## Info Note

## BV-2114 Transformer Improvement

This Information Note provides information about a product improvement in Power Integrations' transformer BV-2114.

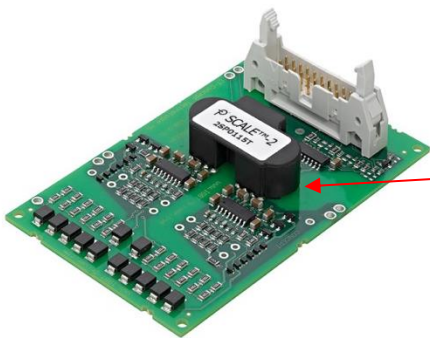
The wire strip process is optimized to improve long term reliability. The wire plastic insulation remains around the wire from inside the potting to where the wire is wrapped around the pins. The wire insulation is only removed very closely to the pins.

2SP0115T2A0-xxxx equipped with BV-2114:

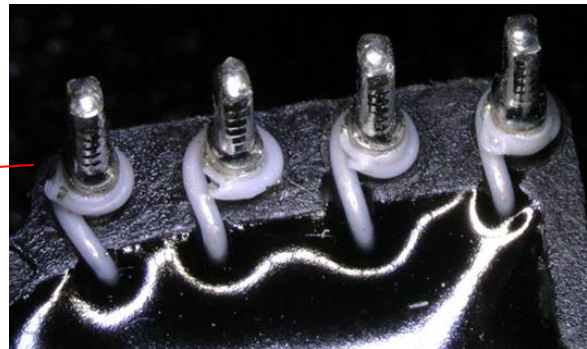
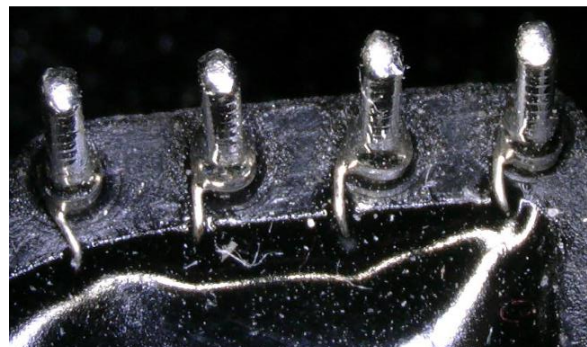
The transformer's revision number will change from BV-2114-1 to BV-2114-2.

BV-2114-2 (improved process):

BV-2114-1 (previous process):
